# Service Bulletin

Bulletin No.: PI0733

**Subject:** Power Seat Functions Inoperative and Air Bag Light Illuminated

**Models:** 2011-2012 Chevrolet Cruze  
Equipped with Adjustable Multi-Directional Driver Power Seat (RPO ADS)  
and Built Prior to August 24, 2011

2851656

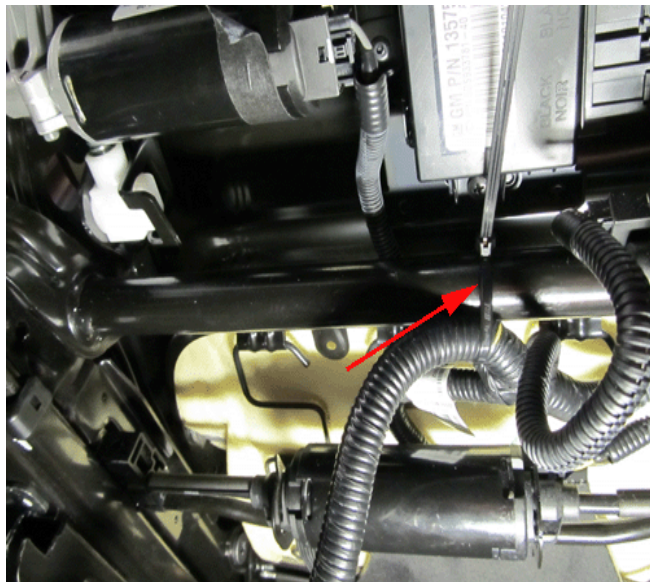
These conditions may be due to the seat harness, which is connected to the main body wire harness located under the seat, being pinched in the seat tracks, causing it to be chafed.

**Note:** Harness shown pinched under the motor bracket.

The driver power wire harness also has other potential pinch points in areas under the driver power seat such as the height scissor, under the motor bracket and during seat installation as shown in the illustrations above.

3. Using a zip tie, take the wire harness and secure tightly on the center of the cross tube, and make sure the harness is away from the three possible pinch points as shown in the illustrations above.
4. Clip the excessive strap tail.
5. Reinstall the seat.
6. Cycle the seat, forward and backward, up and down to ensure that there is a proper wire length to enable the seat to fully travel to the various possible seating positions.
